## NOTICE OF PUBLIC MEETING PLANNING COMMISSION

Planning Commission  
September 11, 2025 @ 5:30 PM

- 1. Preliminary Plat Review for the CW Santa Clara Commercial Subdivision located on the northwest corner of Pioneer Parkway and Red Mountain Drive. McKenna Christensen, Cole West LLC, applicant.
  - 2. Preliminary Plat Review for the CW Santa Clara Residential Subdivision located north of Pioneer Parkway and west of Red Mountain Drive. McKenna Christensen, Cole West LLC, applicant.
  - 3. Preliminary Plat Review for the Solace Townhome Subdivision located on the corner of Rachel Drive and Affirmation Drive. Dustin Garr, New Wave Construction, applicant.

Staff Report

## Phase 1 Entry - Location 1

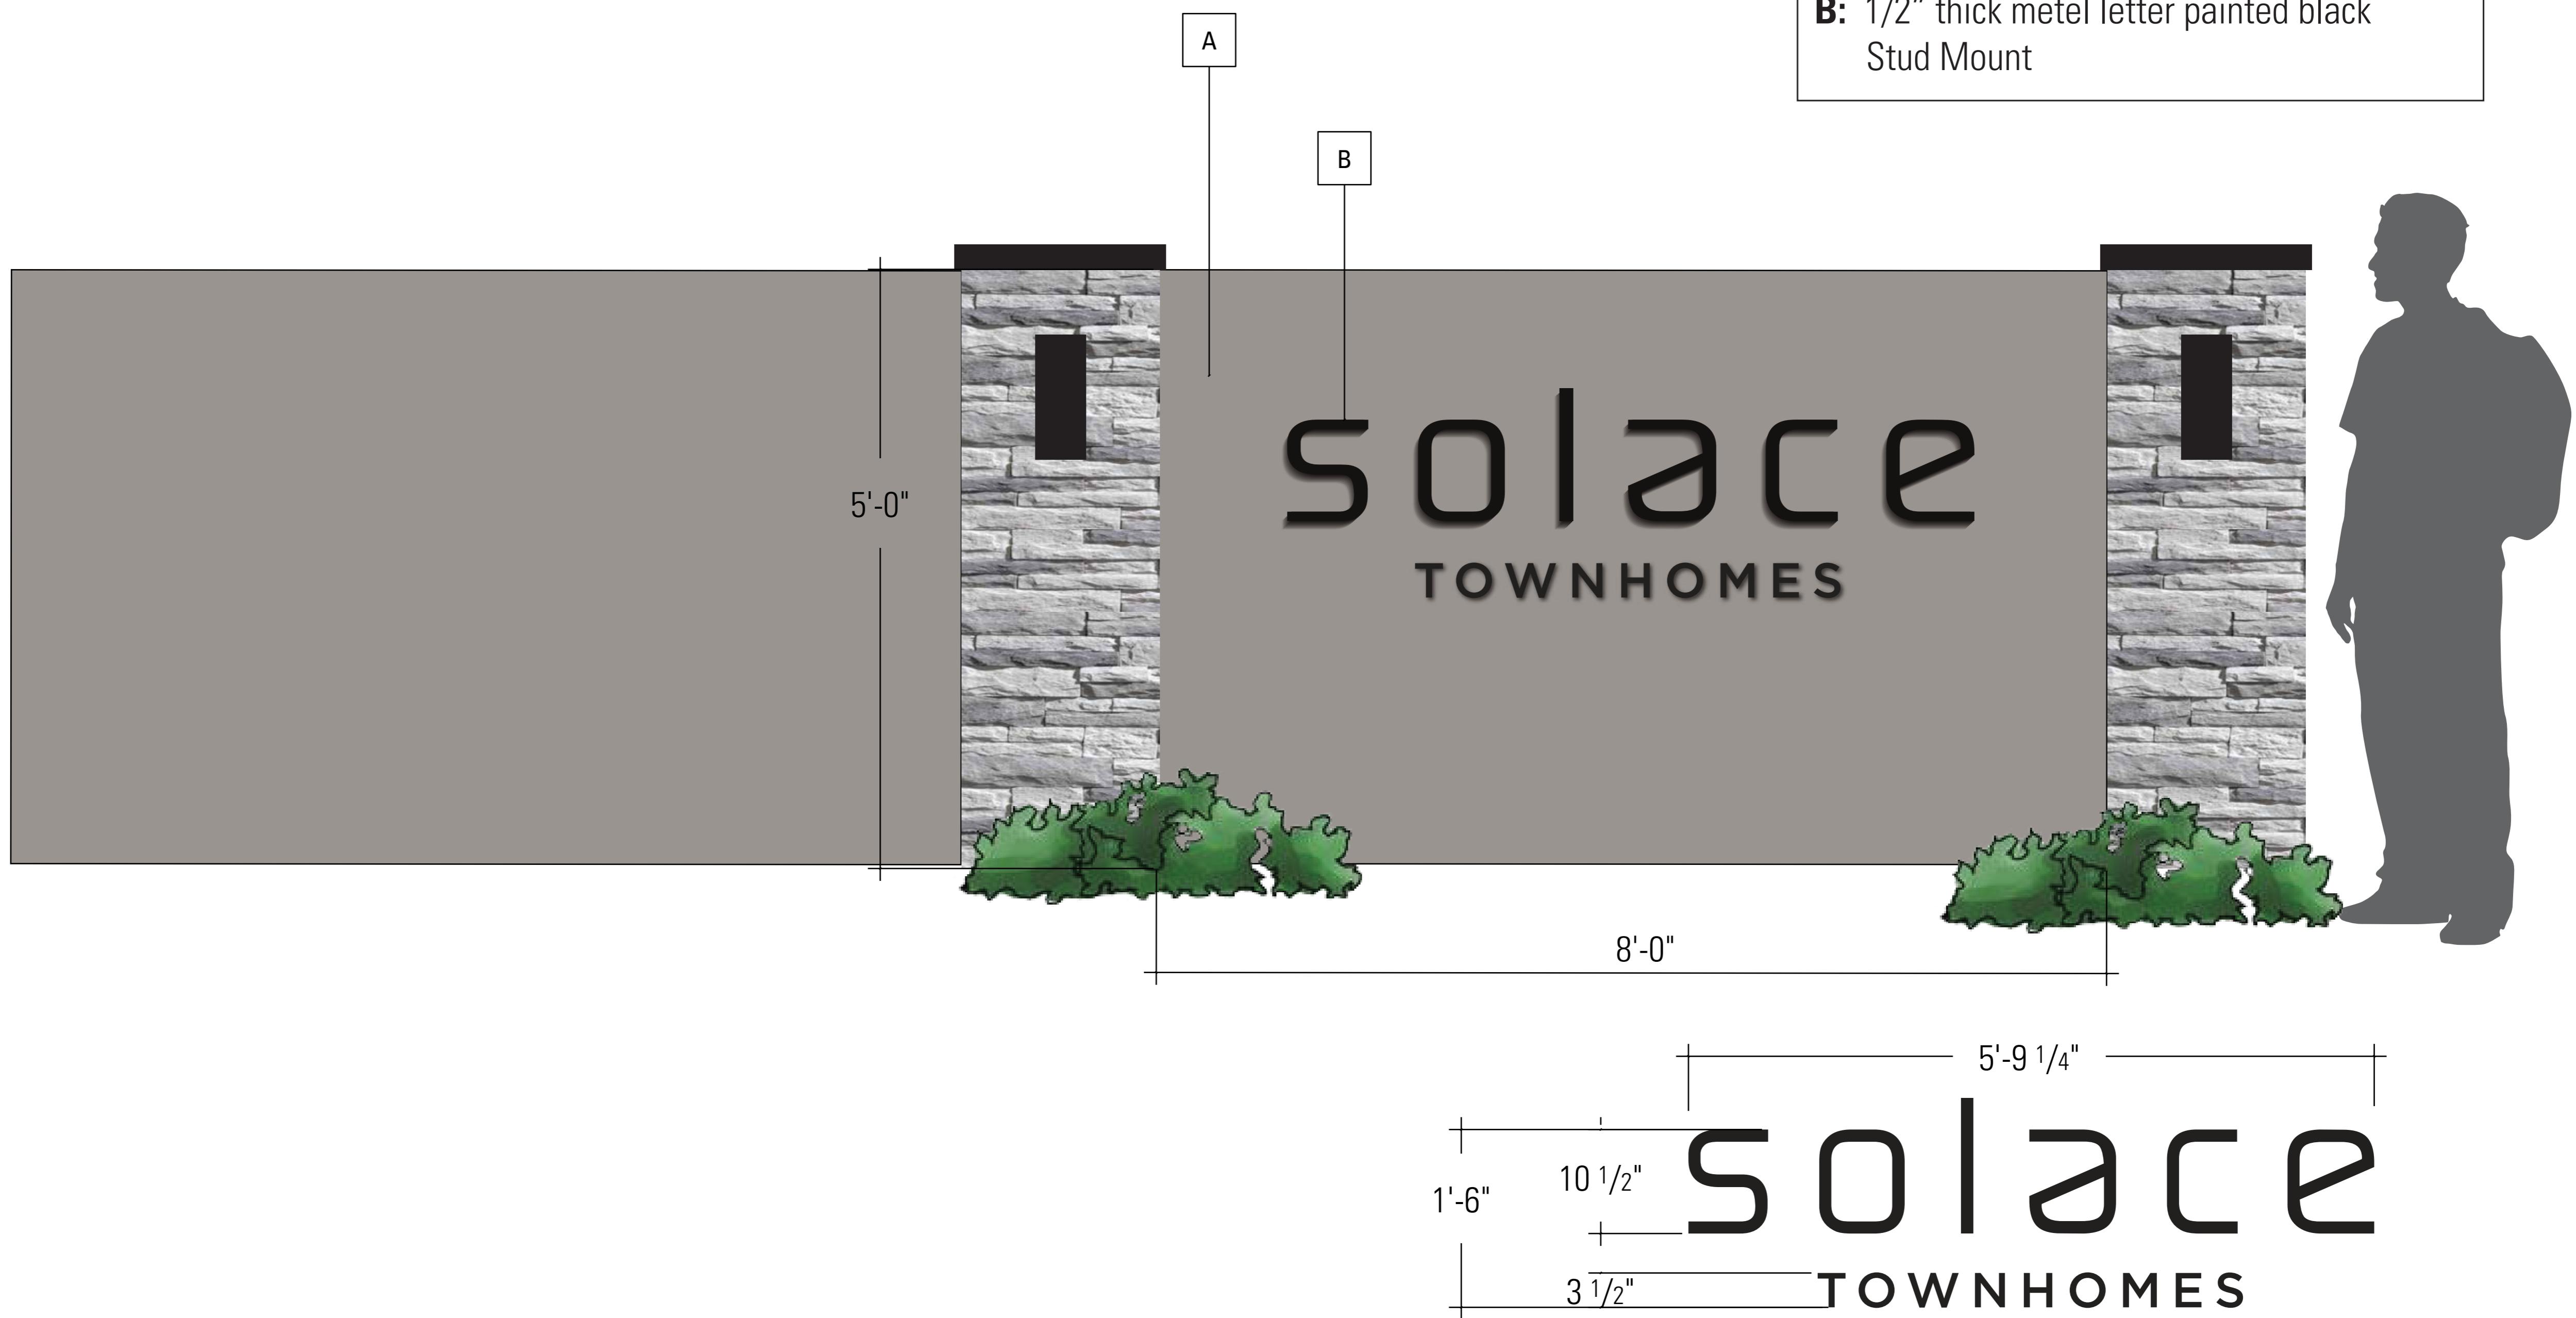
11. **Project Signage/Entry Feature:** The applicant intends to install matching entry signs at the project access points via Affirmation Drive. A **detailed drawing** has been submitted for review. The design appears to be like the existing monument signs for Solace. A building permit will be required prior to sign installation.
